Form C-103
Revised August 1, 2011

| SUNDRY NOTICES AND REPORTS ON WELLS (DO NOT USE THIS FORM FOR PROPOSALS TO DRILL OR TO DEEPEN OR PLUG BACK TO A DIFFERENT RESERVOIR. USE "APPLICATION FOR PERMIT" (FORM C-101) FOR SUCH PROPOSALS.) | | WELL API NO. 30-015-29366 |
| 3. Address of Operator 6301 Deauville Blvd., Midland, TX 79706 | | 7. Lease Name or Unit Agreement Name Todd 2 State |

Chevron USA INC respectfully requests to abandon this well as follows:

**PROPOSED
WELLBORE DIAGRAM**

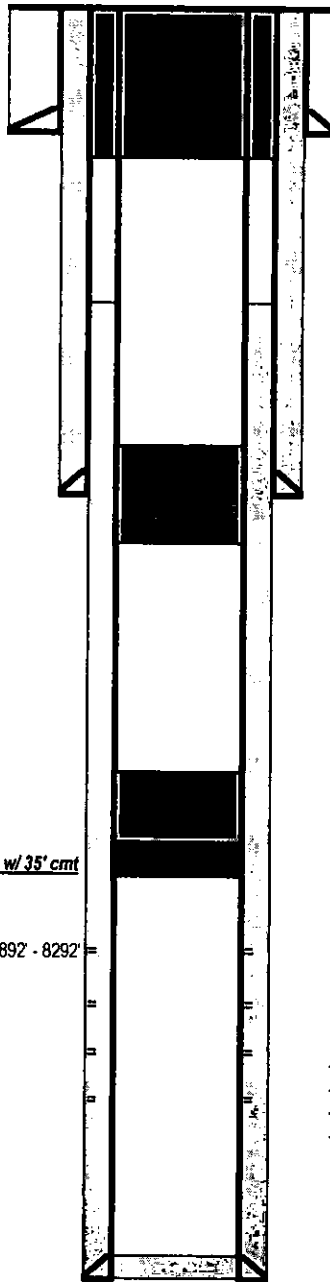
1. MIRU, TIH w/ workstring, tag TOC @ 5895' on top of CIBP @ 5930', fill well with fresh water, pressure test casing to 500 psi for 10 minutes - if the pressure test is good, spot MLF
2. Spot 65 sx CL C cement f/ 5895' t/ 5320' (Cherry Canyon). If pressure test in Step 1 passed, ~~do not~~ WOC & tag. If pressure test in Step 1 failed, WOC, tag, pressure test to 500 psi for 5 minutes - if pressure test is good, spot MLF; if pressure test failed, contact engineer
3. Spot 35 sx CL C cement f/ 4531' t/ 4250' (Lamar, Shoe, B. Salt) - *Perf @ 4440'*
4. Perf & squeeze 285 sx CL C cement f/ 838' t/ surface (Rustler, Shoe, Fresh Water) - *Perf @ 725'*
5. Verify top of cement at surface on all casing strings

** See Attached COA's*

12. **Class 'C' cement will be used above 7500 feet.**
13. **Class 'H' cement will be used below 7500 feet.**
14. **A cement plug is required to be set 50' above and 50' below, casing stubs, DV tools, attempted casing cut offs, cement tops outside casing, salt sections and anywhere the casing is perforated, these plugs require a 4 hour WOC and then will be tagged**

15. **All Casing Shoes Will Be Perforated 50' below shoe depth and Attempted to be Squeezed, cement needs to be 50' above and 50' Below Casing Shoe inside the Production Casing**
